FINISH	HOT DIP GALVANIZED
CUSTOMER	FORESTSIDE ESTATES INC
PROJECT	66-95 ATTAMAR DRIVE (BLDG. C)
LOCATION	BRAMPTON, ONTARIO
DETAIL	EXTERIOR GALVANIZED EXHAUST SHAFT GRATING
DRAWN BY	BL
CHECKED BY	SCALE AS NOTED
DATE	MAY 19/2021
DRAWING NO.	21-000C-MS1

EXTERIOR GALVANIZED AIRSHAFT GRATING FOR BUILDING 'A'

FINISH	HOT DIP GALVANIZED		
CUSTOMER	FORESTSIDE ESTATES INC		
PROJECT	GG-95 ATTMAR DRIVE (BLDG. A)		
LOCATION	BRAMPTON, ONTARIO		
DETAIL	EXTERIOR GALVANIZED AIR SHAFT GRATING		
DRAWN BY	BL	CHECKED BY	DRAWING NO.
DATE	MAY 19/2021	SCALE	A5 NOTED
			21-000A-M51

MASTER STEEL FABRICATION LTD.

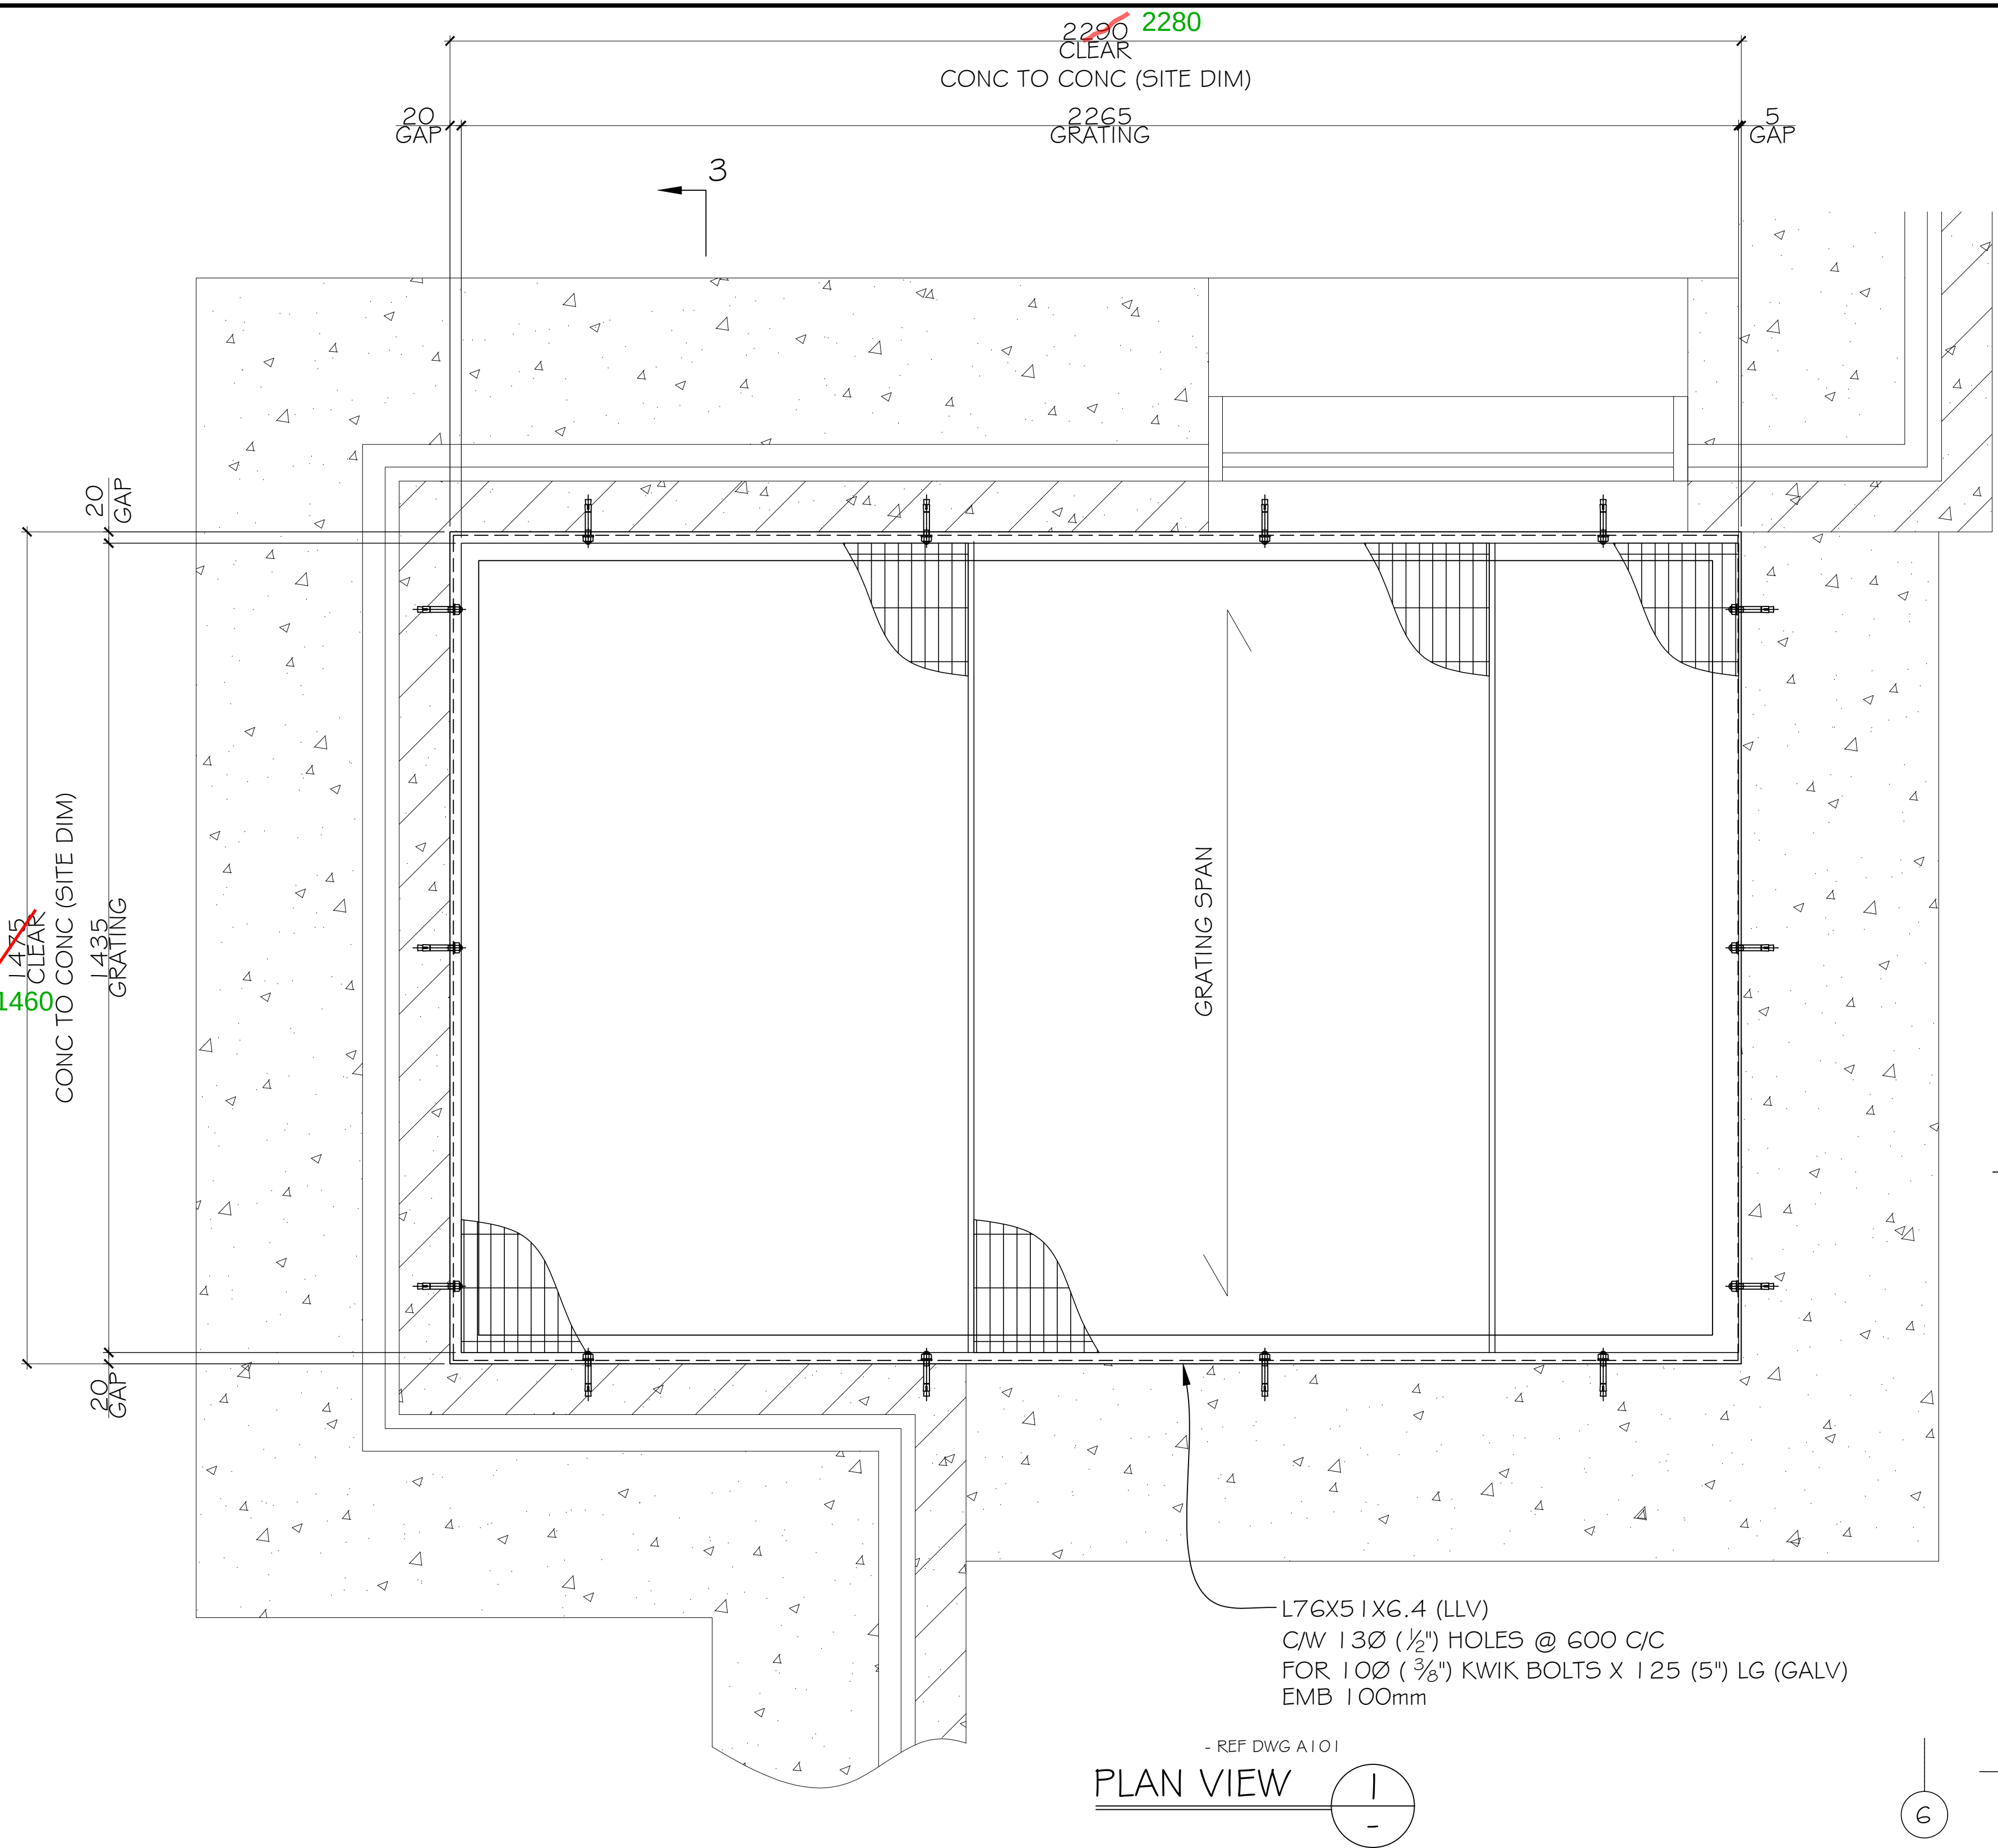
PROVIDE PENG STAMP

CONFIRM IF IT NEEDS TO BE DESIGNED FOR HEAVY TRUCK LOADING

G+C:
all beams dimensions must be checked by Structure, in terms of size and load.
